APPLICATION NO.	FILING DATE	FIRST NAMED INVENTOR	ATTORNEY DOCKET NO.	CONFIRMATION NO.
10/580,379	02/13/2007	Raymond John Bacon	508-051,009	2557

# Office Action Summary

BACON, RAYMOND JOHN

Fig. 2 of Brunet as annotated by examiner

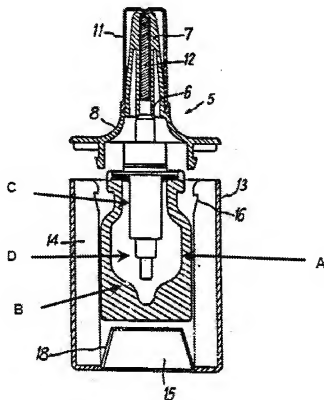
Regarding claim 3, Brunet shows that the minor portion (B in examiner annotated figure below) of the reservoir has a progressively diminishing cross section whereby the rate of fall of the level of substance increases as it is further depleted (inherent effect from diminishing cross section).

Regarding claims 11, 13 and 14, Brunet shows that the reservoir is provided with a slug (C, D in examiner annotated figure below) which substantially reduces the cross-section thereof, includes a uniform cross section (C in examiner annotated figure below

has constant cross section) and is tapered (D in examiner annotated figure below tapers).
